Laguna Madre Water District
Wastewater Treatment Plants Rehabilitation
 September 2016

Isla Blanca WWTP
Site Plan And
Mechanical Modifications
To Existing Plant

Isla Blanca WWTP
Chlorination & Dechlorination
Equipment

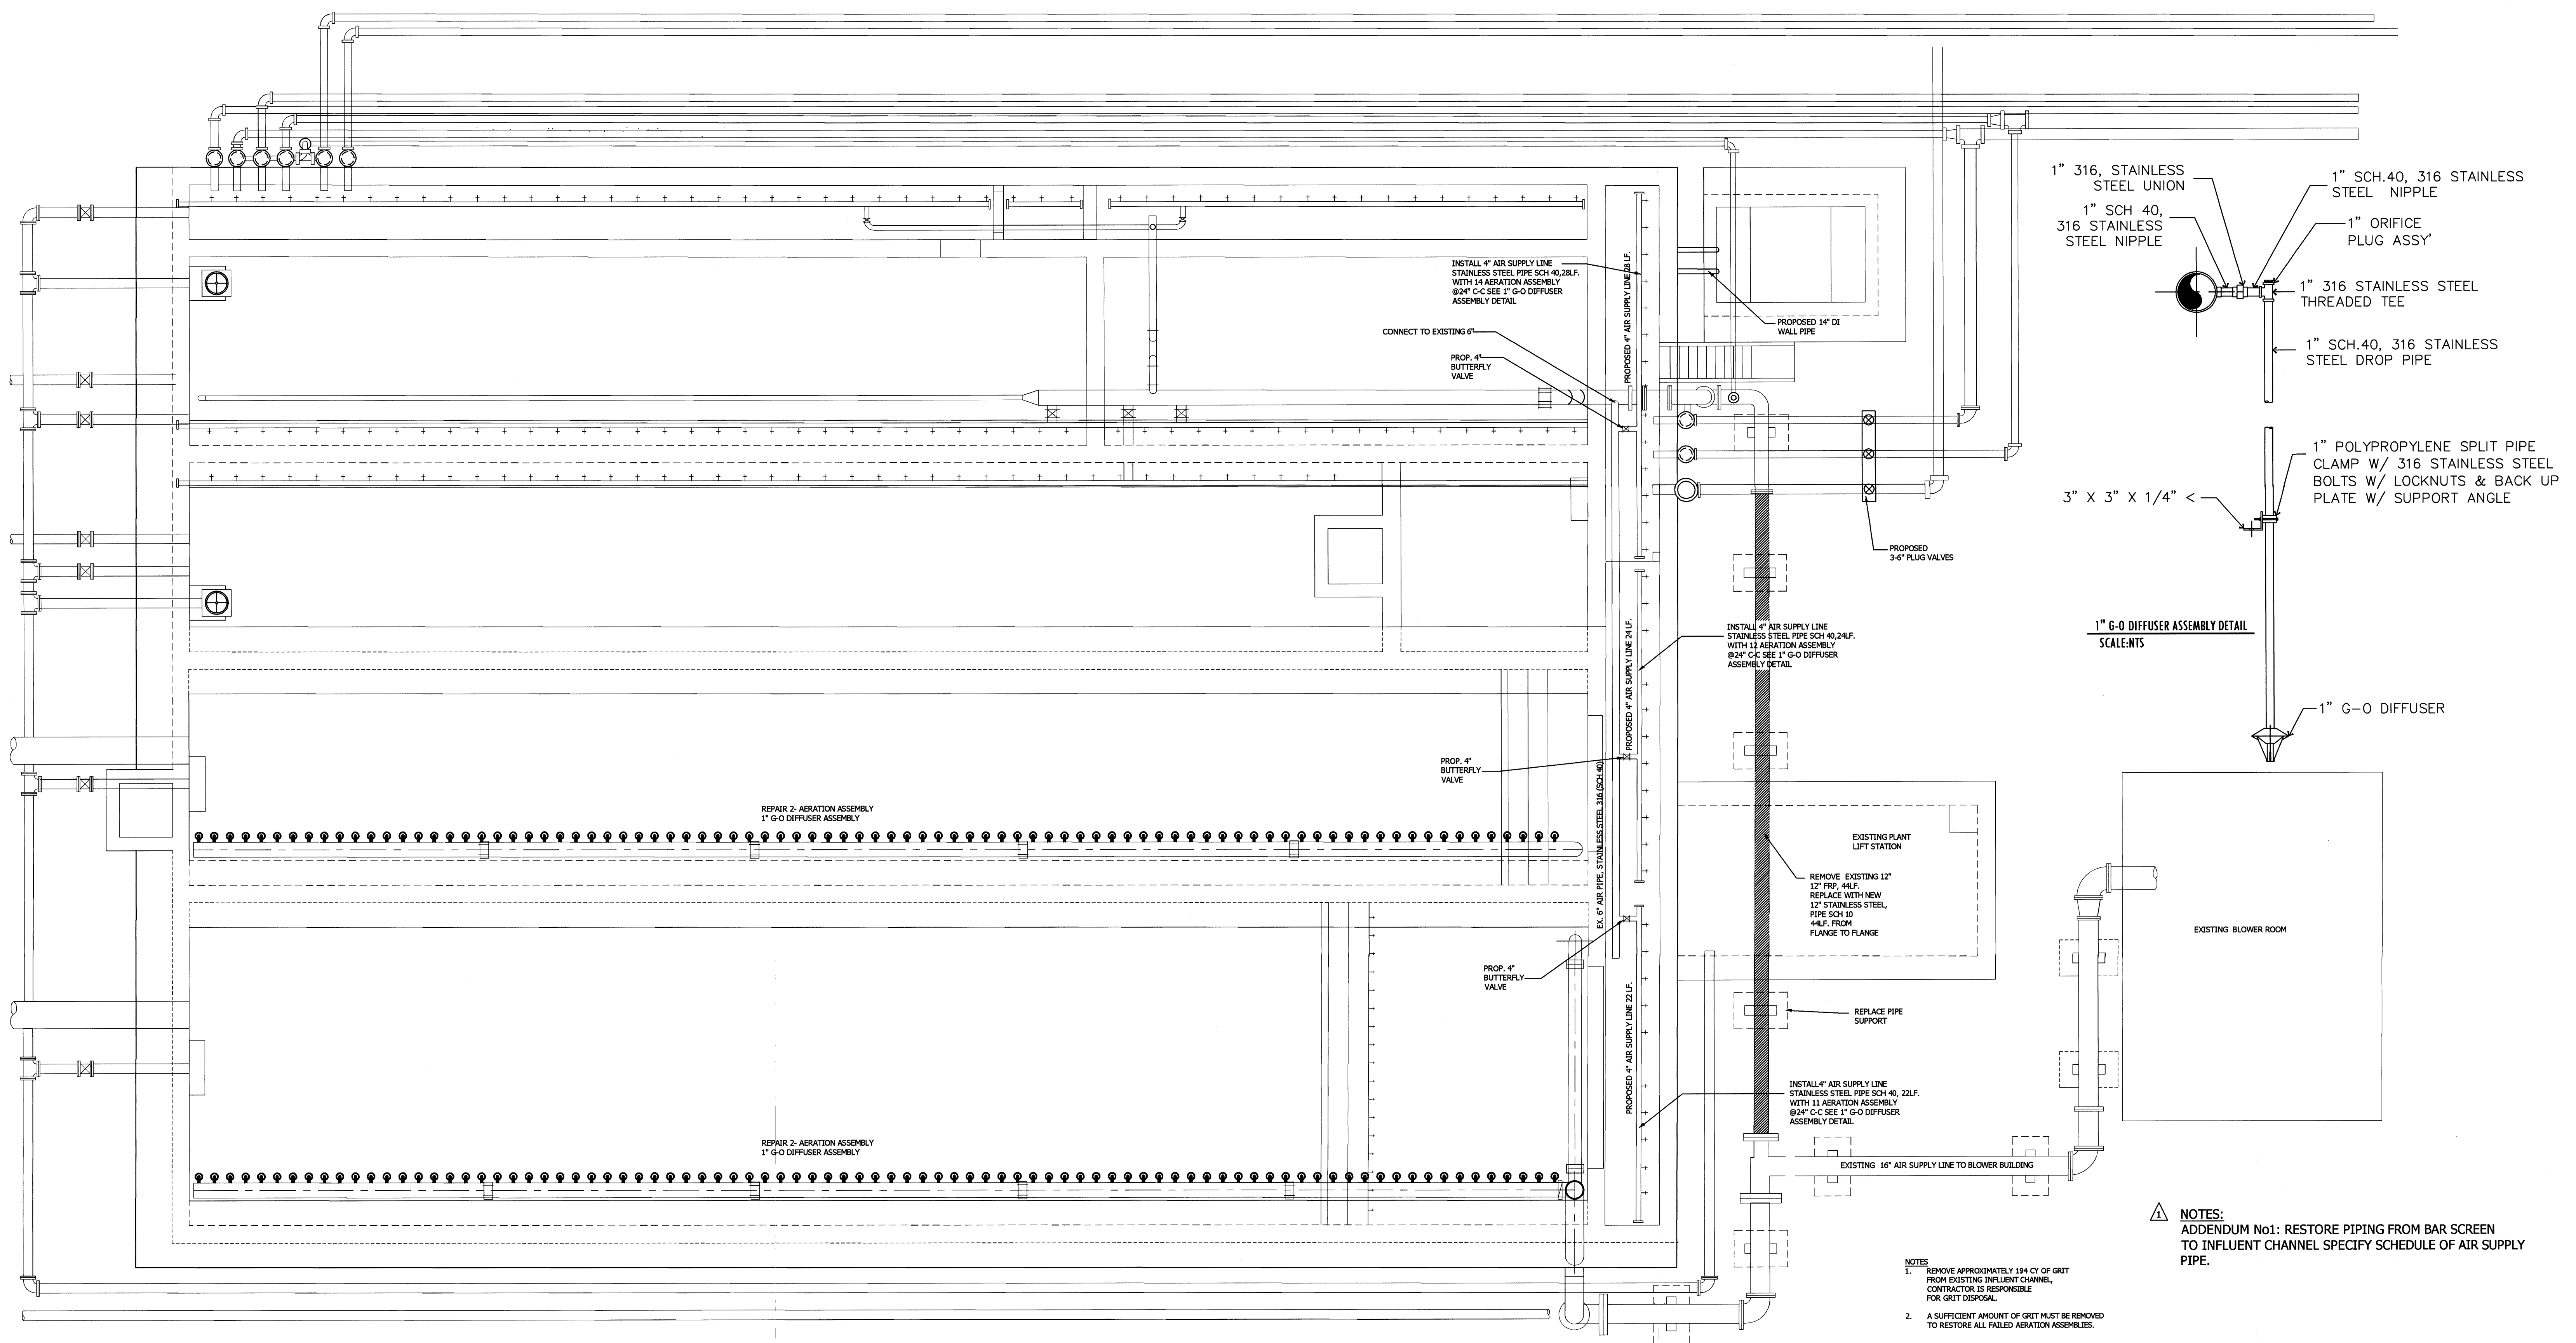
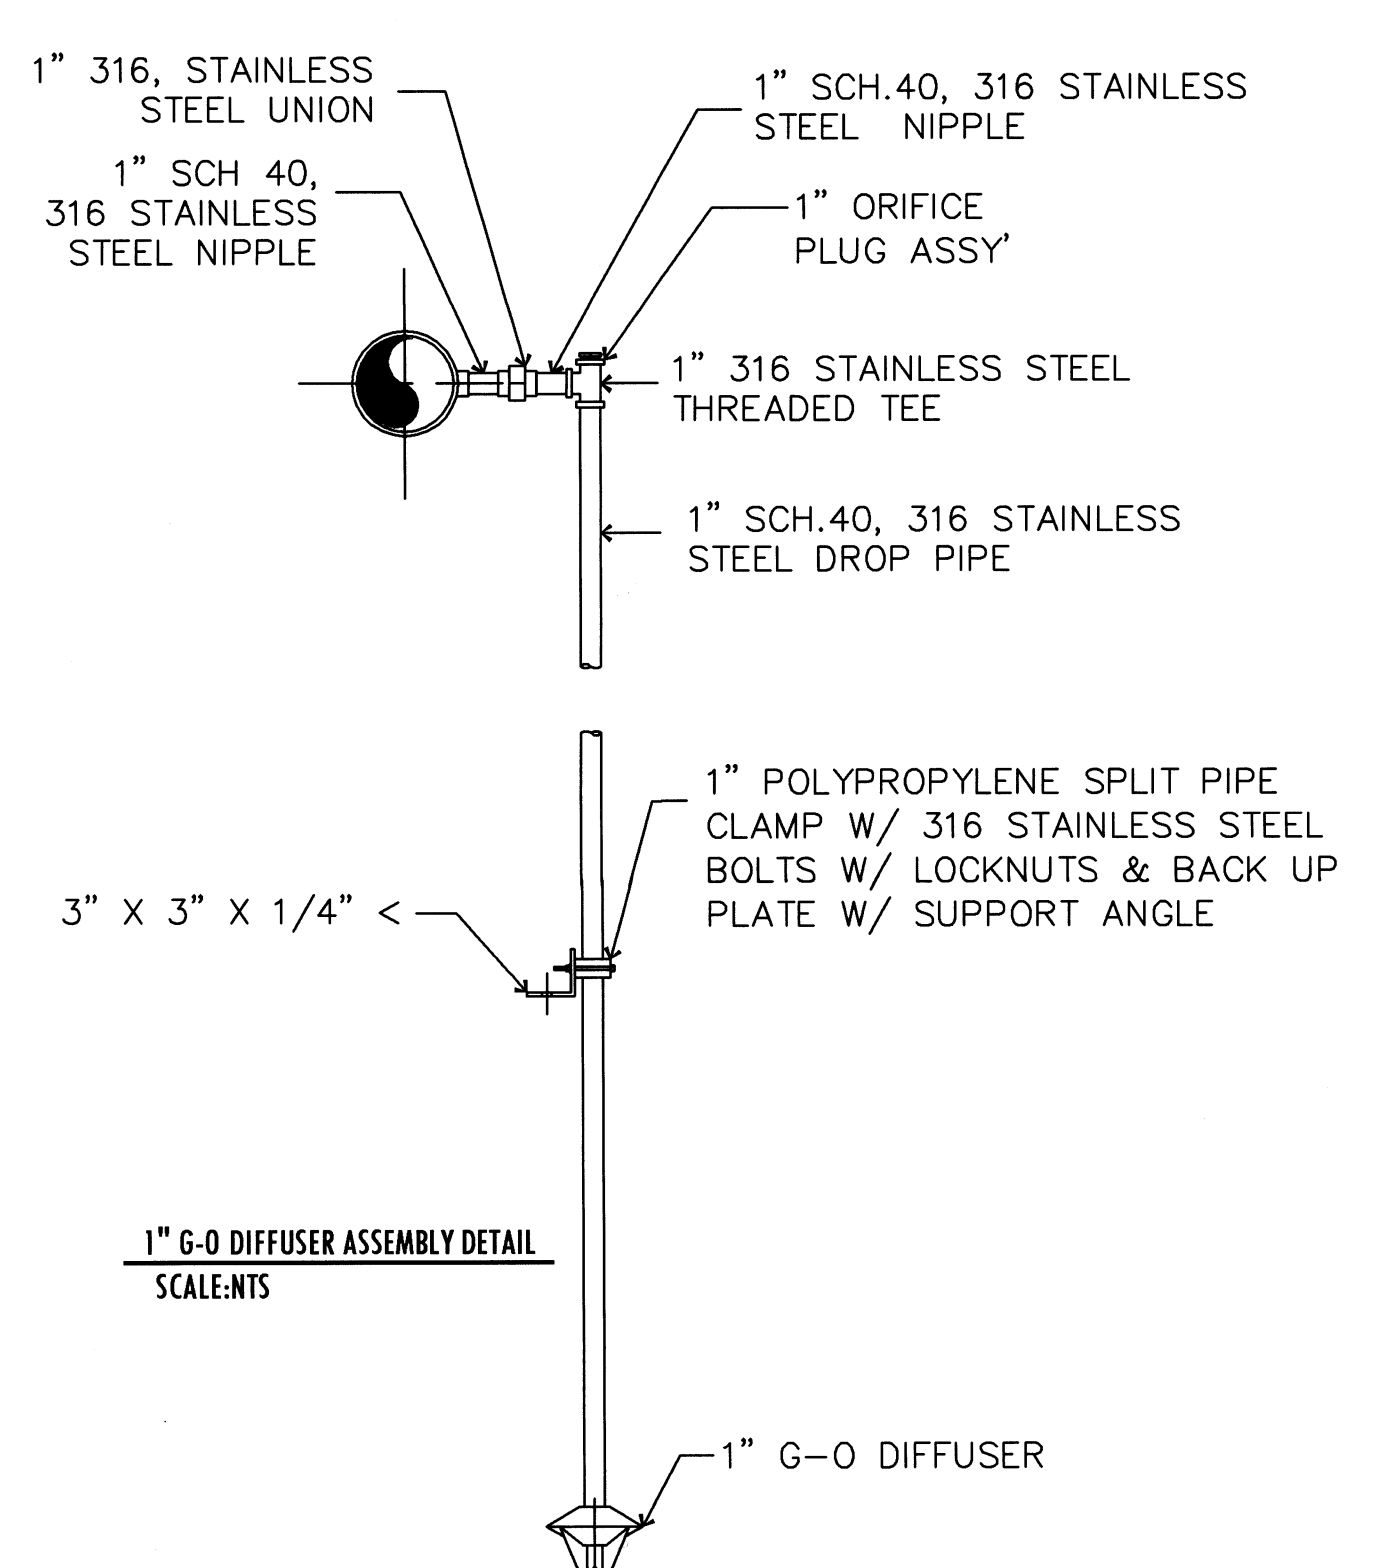
NOTES:
ADDENDUM No1: SIZE ALL PROPOSED ROTAMETERS FOR 250 PPD. DISTRICT DOES NOT USE INDUCTION PUMPS FOR CHLORINATION AND DECLORINATION EQUIPMENT. EXISTING VENTURI SYSTEM TO REMAIN IN PLACE. AUTOMATIC SWITCHOVER REMOVED FROM ALL VACUUM REGULATORS. RESTORE EJECTORS AT ALL SITES.

Laguna Madre Water District
 Andy Bowie Wastewater Plant
 Site Plan and Mechanical Modifications To
 Air Supply Line

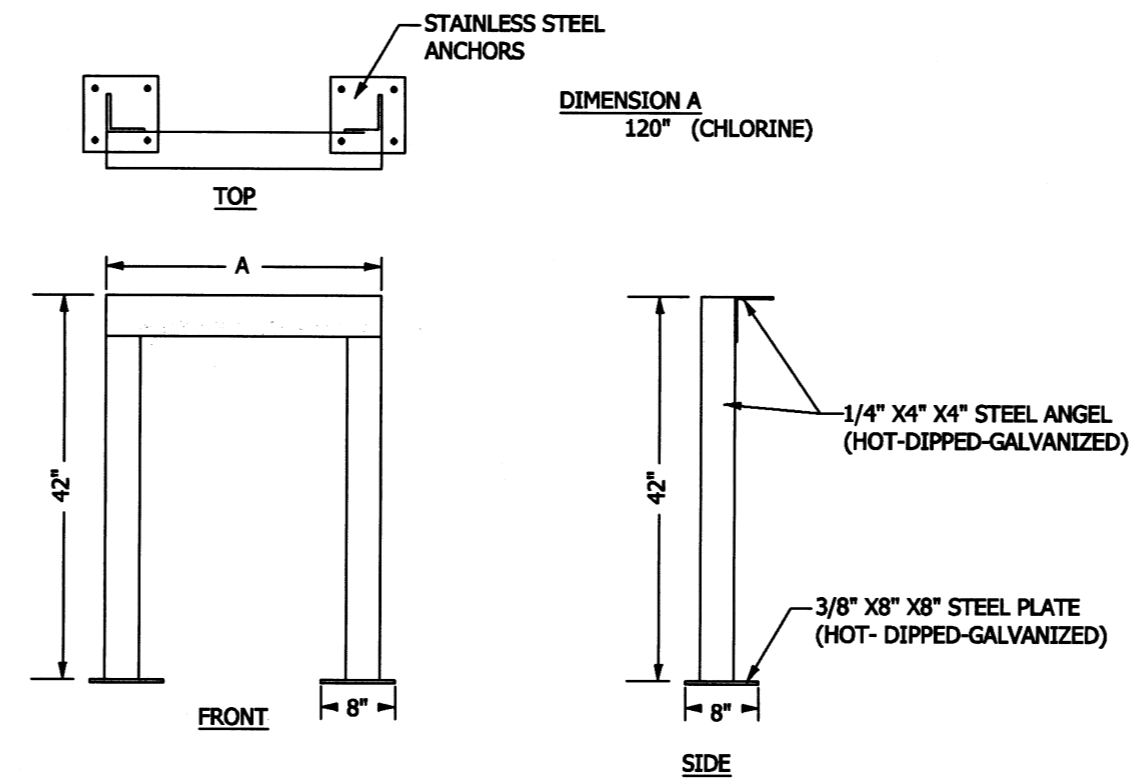
- NOTES:**
- ADDENDUM No1: RESTORE PIPING FROM BAR SCREEN TO INFLUENT CHANNEL SPECIFY SCHEDULE OF AIR SUPPLY PIPE.
1. REMOVE APPROXIMATELY 194 CY OF GRIT FROM EXISTING INFLUENT CHANNEL. CONTRACTOR IS RESPONSIBLE FOR GRIT DISPOSAL.
2. A SUFFICIENT AMOUNT OF GRIT MUST BE REMOVED TO RESTORE ALL FAILED AERATION ASSEMBLIES.

BAR SCREEN MECHANICAL PLAN SCALE: NTS

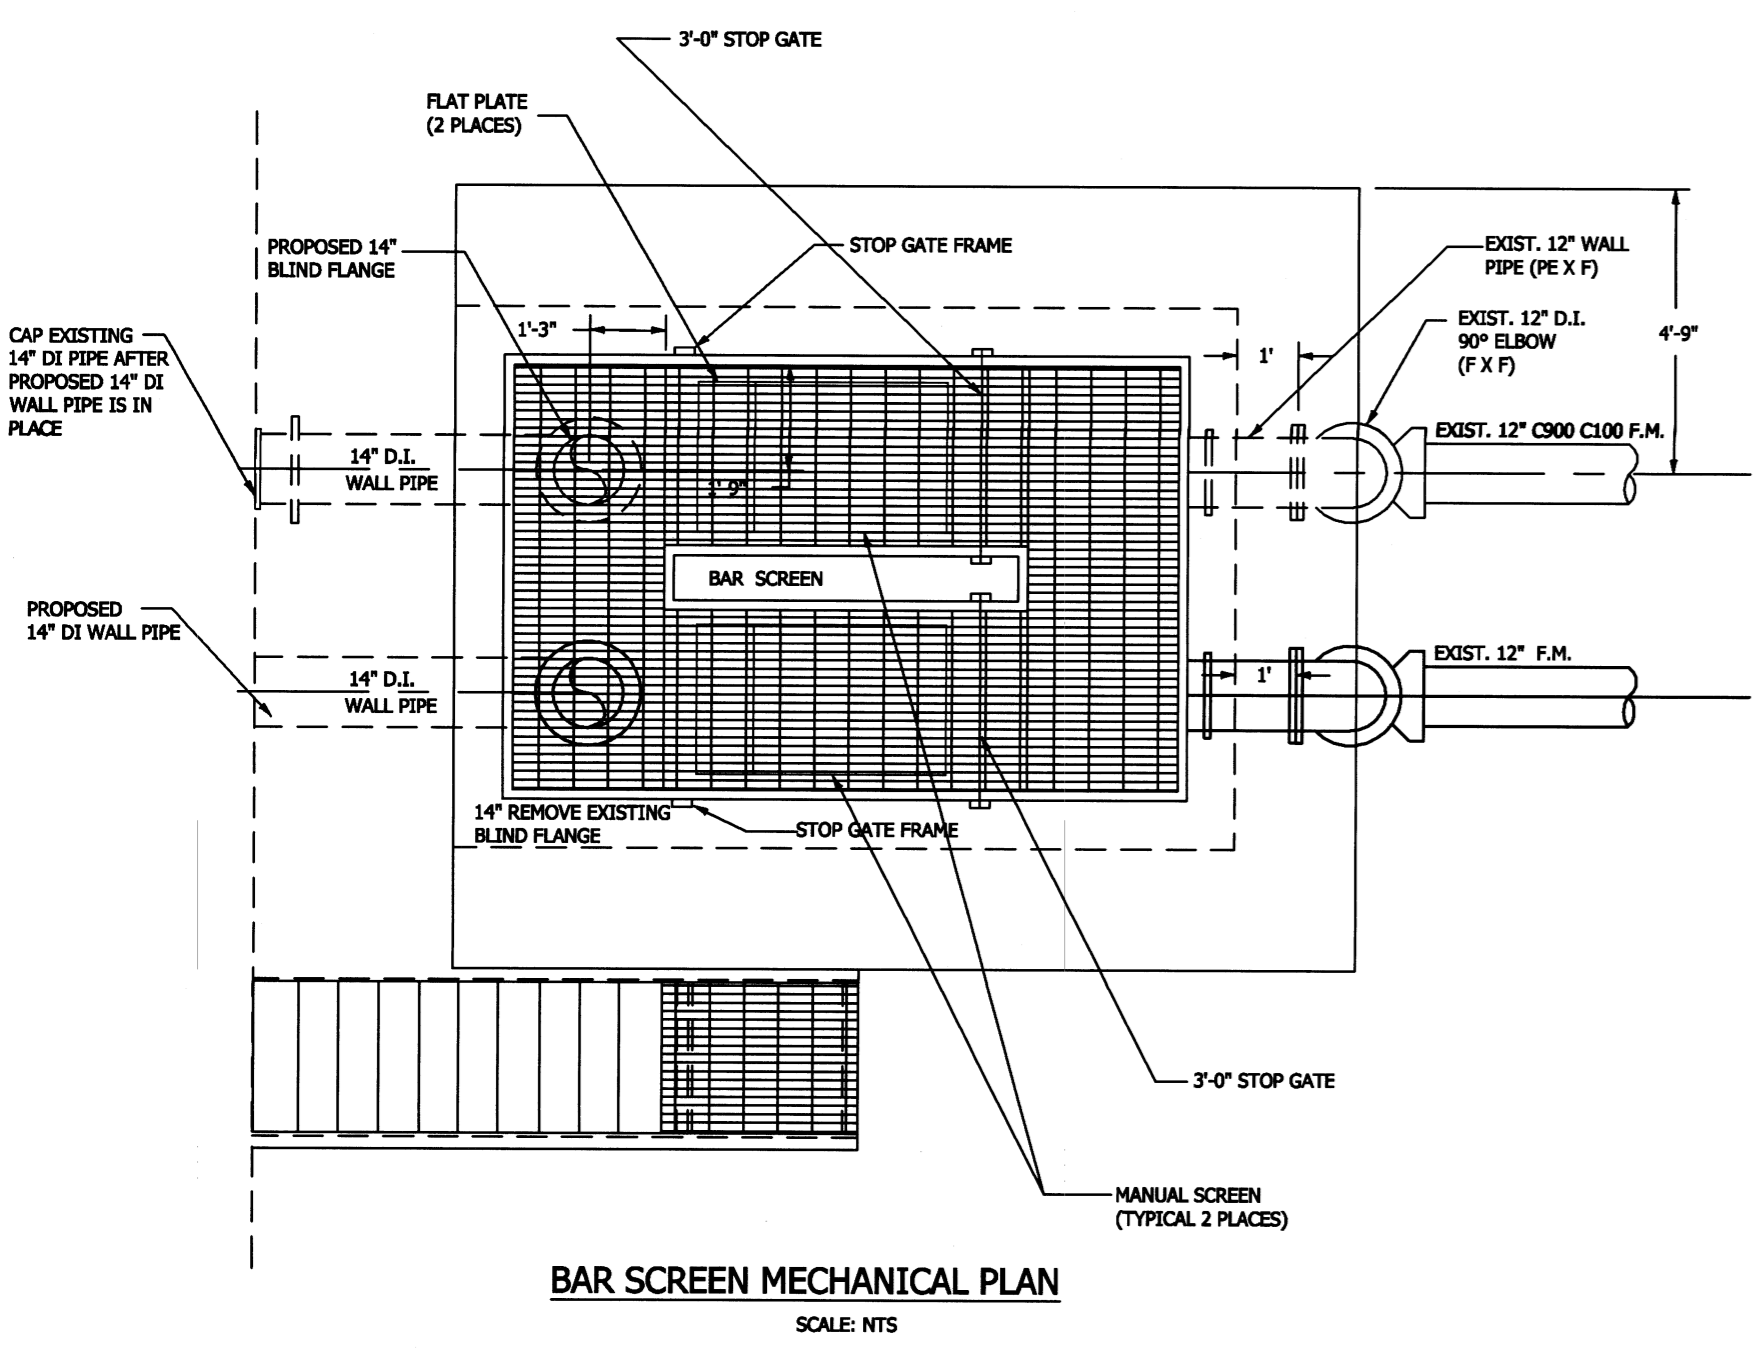
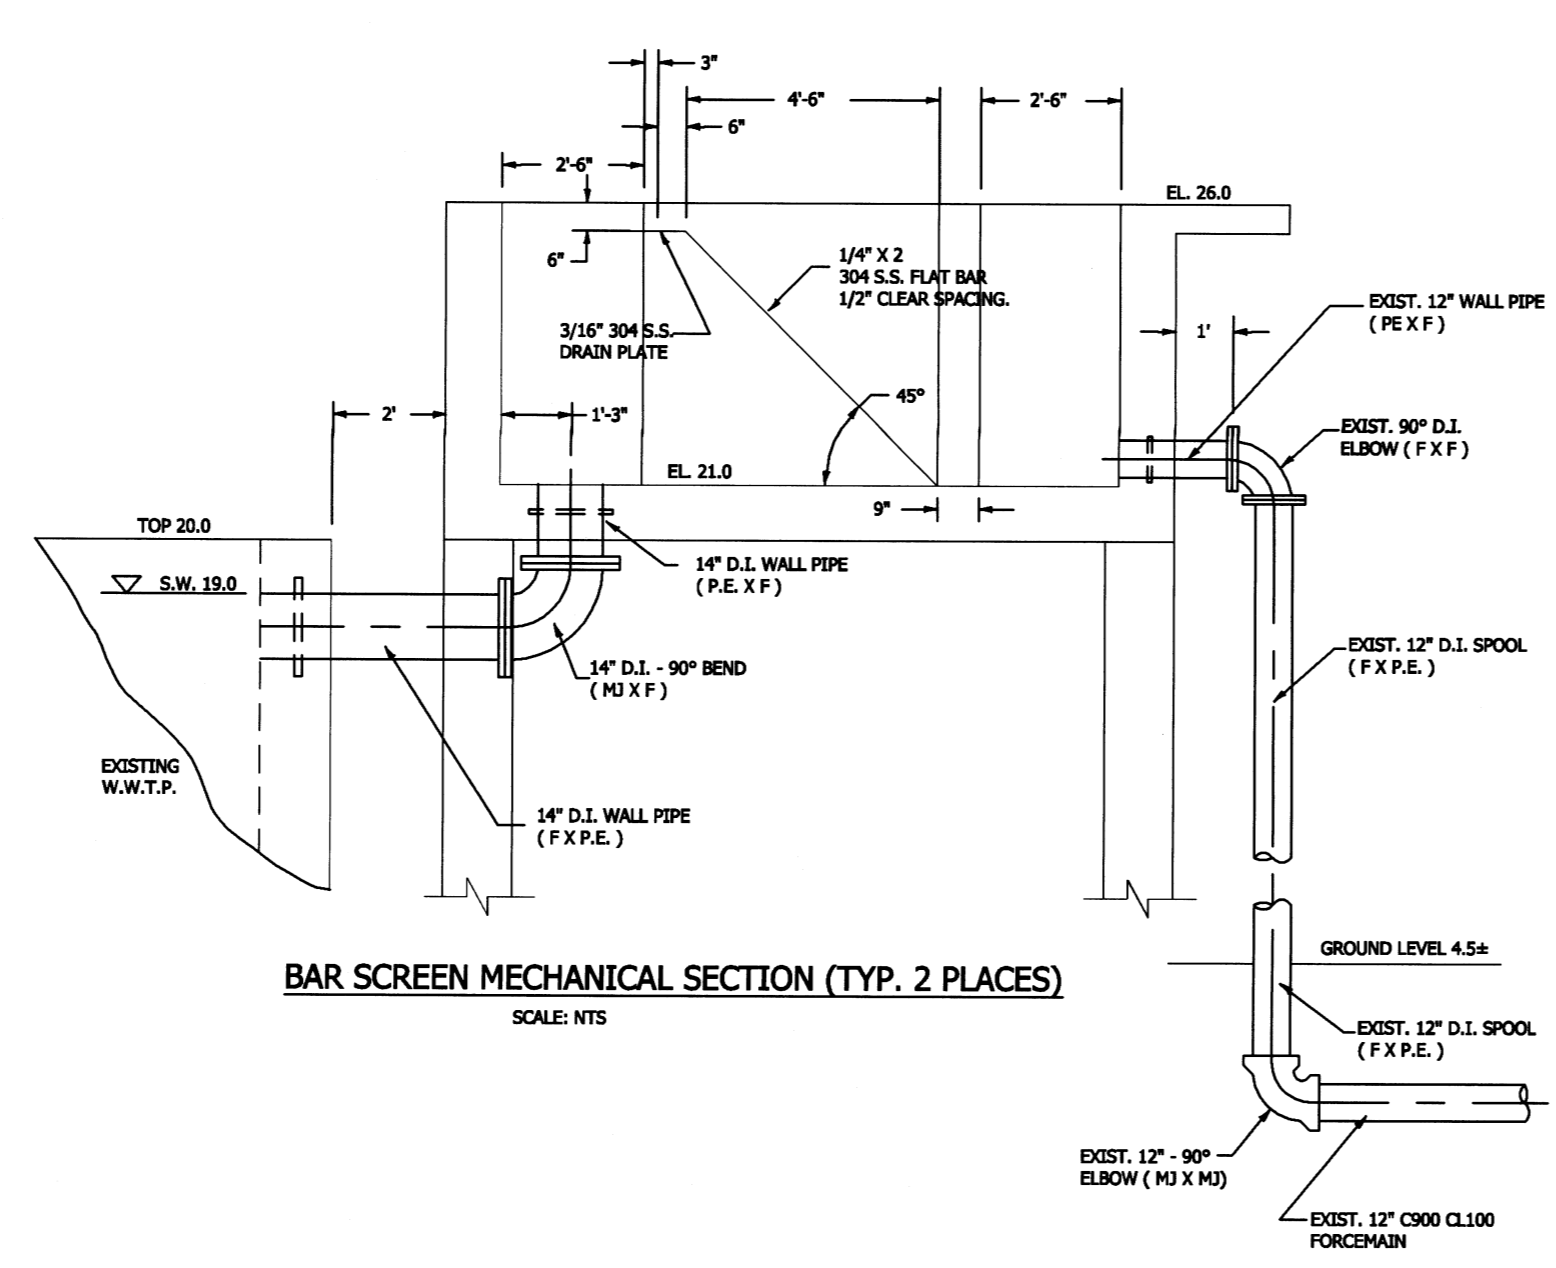
NOTES:
 ADDENDUM No.1: PROVIDE DUAL SENSOR FOR CHLORINE AND SULFUR DIOXIDE LEAK DETECTORS.
 ADD SECOND 14" D.I. WALL PIPE AS SHOWN IN BAR SCREEN MECHANICAL PLAN.
